P1 Project Drawing Updates - 10/22/2019

BR-549-A-002

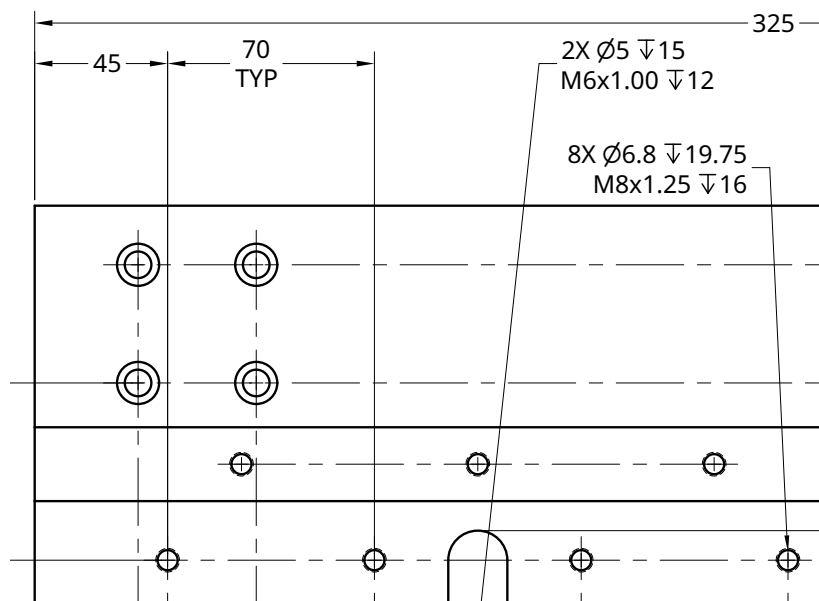
Groove diameter was missing

BR-549-B-001

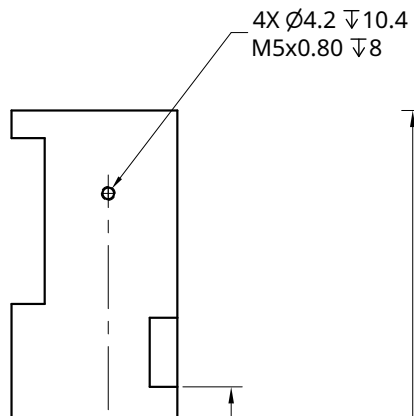
4 holes were missing hole callouts

BR-549-B-006

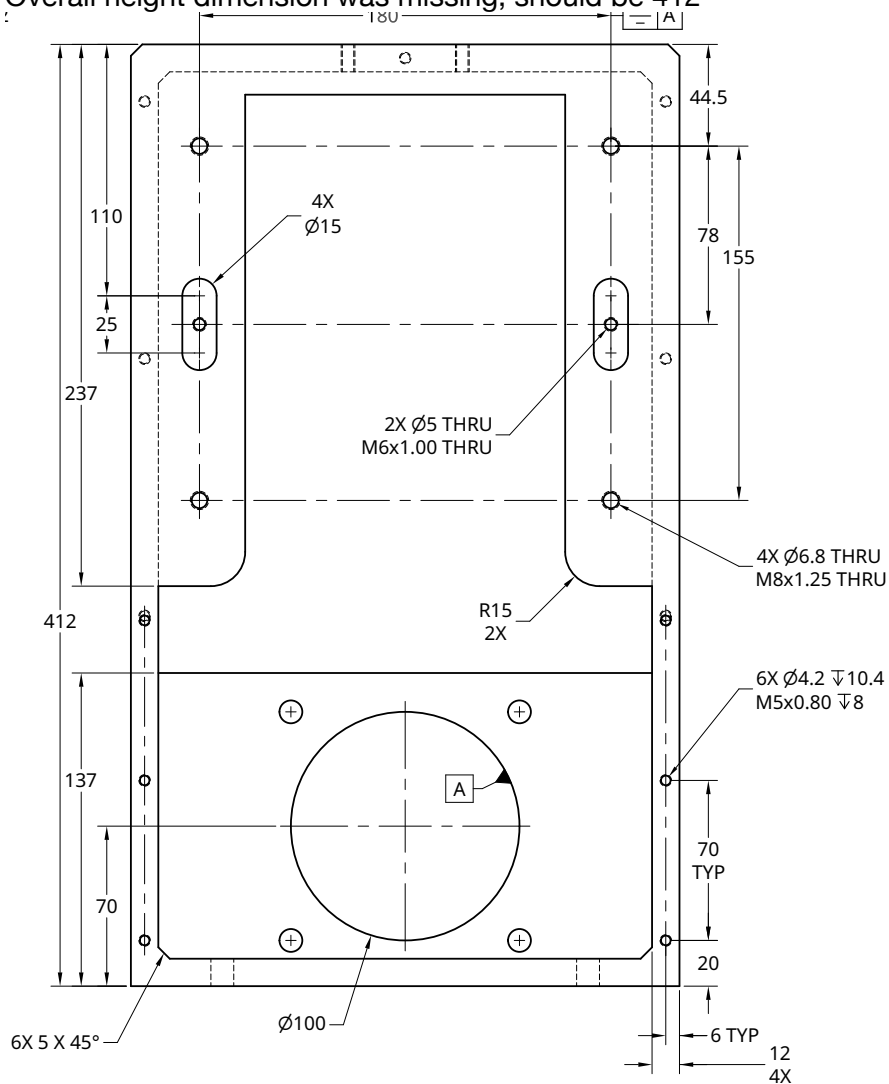
Overall height dimension was missing; should be 412

BR-549-C-001

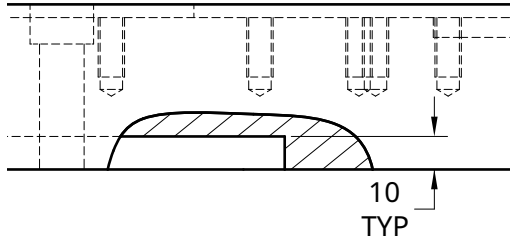
Keyway depth dimension was missing
